Request for Class II Permissive Change

FCC ID: **YZZGVC3200**

GVC3202 is GVC3200 derivative. The main difference is that GVC3202 main board removed the HDMI OUT3 Interface and replaced the OLYMPUS lens with UNION len.

Original main board photo

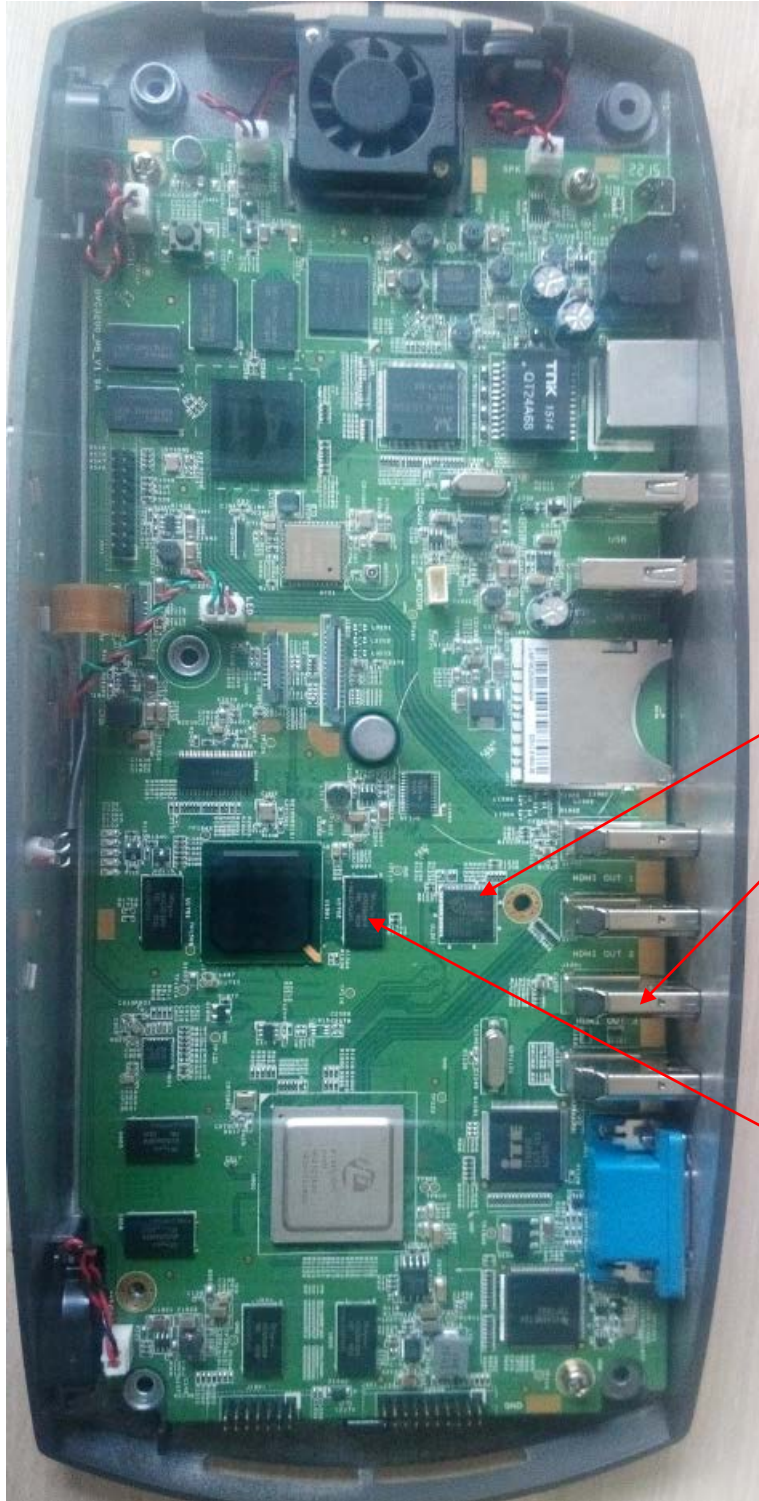
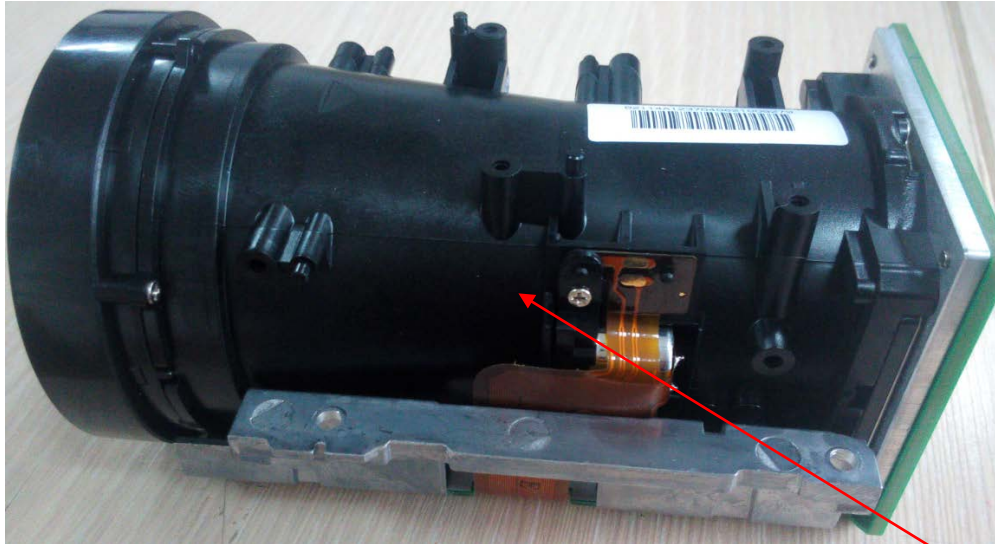
1. Removed the HDMI OUT3 socket J1201; Removed the HDMI transmitter U1201;
Removed the HDMI OUT3 TVS array.
 2. Removed the FPGA DDR3 memory U1702.
 3. replaced the OLYMPUS len with UNION's.
 4. The fixing holes on the sensor board moved 3mm further away from the PCB edge in the horizontal direction.
 5. The socket CON1 on the lens-driver board moved 3mm further to the near PCB edge in the vertical direction.
 6. Wireless module and it's antenna is exactly identical as before.
- Anything else are the same as before.(pls see EUT photos below)
